Authorized Field Change

AFC G-02907

Subject: Relocation of the Transfer Case Breather and Install a Breather into the Neutral Position Air Inlet Port in 7300, 7400, and 7500, 4X4 and 6X6 Models Built Between September 27, 2001 and July 30, 2002

Figure 1 **Install Air Fitting**

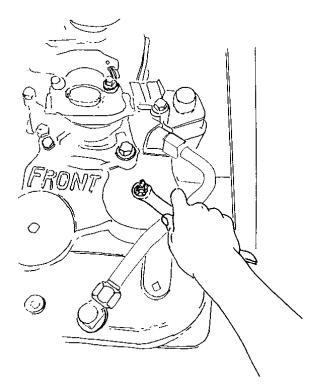
- Remove the breather and 90 degree elbow from the front of the transfer case.
- Install an air fitting into the breather bore (Figure 1). 2.

Figure 2 Connect Air Supply

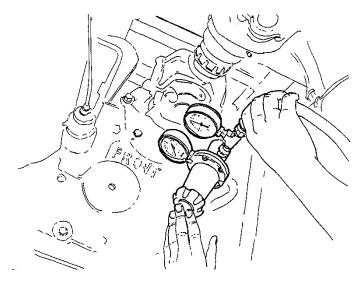
3. Connect a 10 PSI maximum regulated air supply to the air fitting (Figure 2) to pressurize the transfer case.

Figure 3 Transfer Case Boss (Arrow)

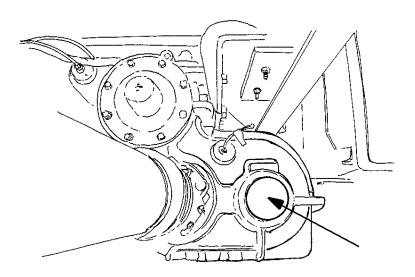
4. At the rear of the transfer case, locate the boss shown in Figure 3.

Figure 4 Locate Boss Center

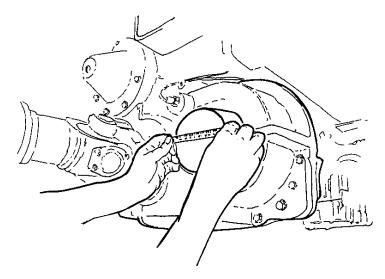
5. Locate the center of the boss (Figure 4) and center punch (Figure 5).

Figure 6 Position Magnet at Drill Location

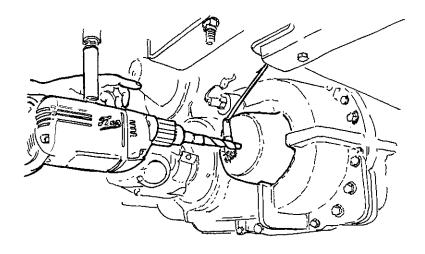
6. Position a magnet as close as possible to catch metal chips and drill through the boss with a 19/32 inch drill bit (Figure 6 and Figure 7).

Figure 8 Tap Hole

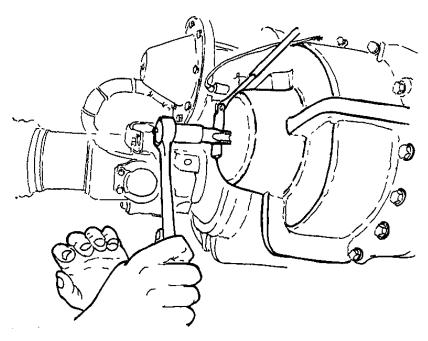
7. Tap the hole with a 3/8–18 NPT pipe tap (Figure 8).

Figure 10 Install Breather

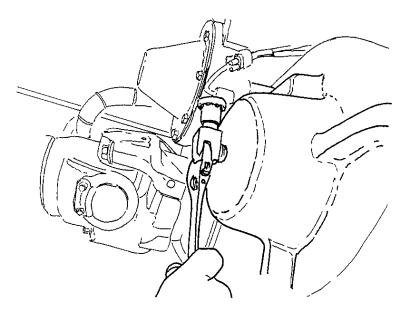
9. Install the breather and elbow with thread sealant into the new hole. Tighten the breather to 20 to 25 Lbf-ft (27 to 34 Nm) making sure to position the breather in the vertical up position (Figure 10).

Figure 11 Top View of Transfer Case with Neutral Position Air Inlet Port Shown at Arrow

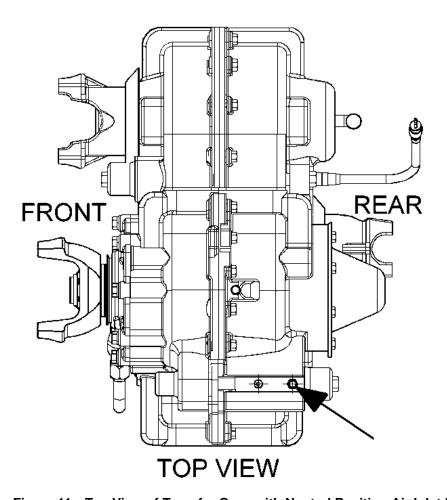
- 10. Install a 3/8–18 pipe plug with thread sealant into the original breather hole at the front of the transfer case. Tighten to 20 to 25 Lbf-ft (27 to 34 Nm).
- 11. Locate the neutral position air inlet port shown in Figure 11 and remove the pipe plug.

12. Install reducer bushing, Part Number 2585584C1, and breather, Part Number 2585583C1, with thread sealant. Tighten the reducer bushing to 15 to 20 Lbf-ft (20 to 27Nm) and the breather to 5 to 7 Lbf-ft (7 to 9 Nm).
